Drawing Name: BUBBLE WINDOW, RH

| 1 | DESIGN CP DRAWN BY | | DART AEROSPAC HAWKESBURY, ONTARIO, C | |
|---|--------------------|----------|---|------------------------|
| 0 | CHECKED | APPROVED | DRAWING NO. D3269 | REV. C SHEET 1 OF 1 |

| DESIGN | P DRAWN BY | DART AEROSPACE LTD HAWKESBURY, ONTARIO, CANADA | | | | |
|---------------|------------|--|--------------|--|--|--|
| DATE 06.06.26 | 6 | BUBBLE WINDOW INSTALL MOD. | SCALE NTS | | | |

DART SERVICE INSTRUCTION

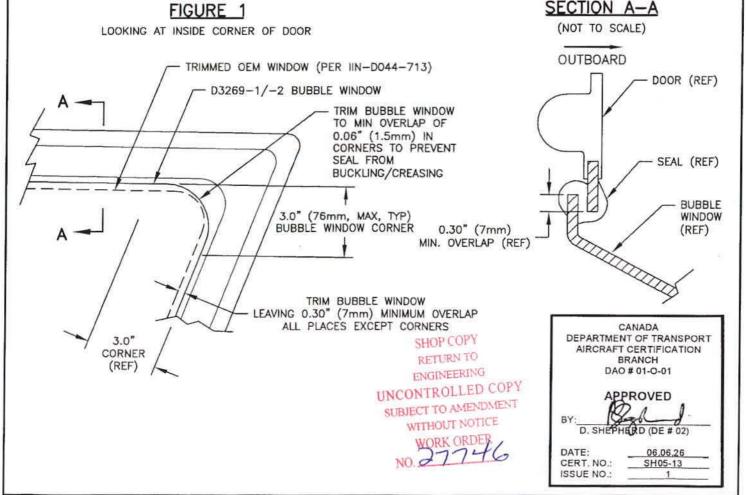
| DESIGN | P DRAWN BY | DART AEROSPACE LTD HAWKESBURY, ONTARIO, CANADA | | | | |
|---------------|------------|--|--------------|--|--|--|
| В | 06.06.26 | CHG TO EFFECTIVE AFTER CHG 002 | | | | |

For the D044-713-013/-014 kits supplied after CHG 002, the D3267-1/-2 bubble windows have been supplied untrimmed to allow for easier installation in the field. The installer must trim the windows in accordance with these instructions prior to installation.

- 1) Modify the R44 crew door per items 3.2.1 and 3.2.2 of Installation Instructions IIN-D044-713 Rev.A.
- 2) Fit and trim the D3269-1/-2 Bubble Window to match the cutout in the door as follows: The bubble window must be a minimum of 0.30" (7mm) larger than the cutout in the OEM window as shown in the figure below. However, in the corners of the window, it is acceptable to trim a 0.06" minimum overlap (1.5mm) to help prevent the D2126-0903 Seal from buckling/creasing in the corners. The edge of the bubble window must be deburred to a smooth finish.
- 3) Continue installing the bubble window per items 3.2.3 through 3.2.5 of the installation instructions.
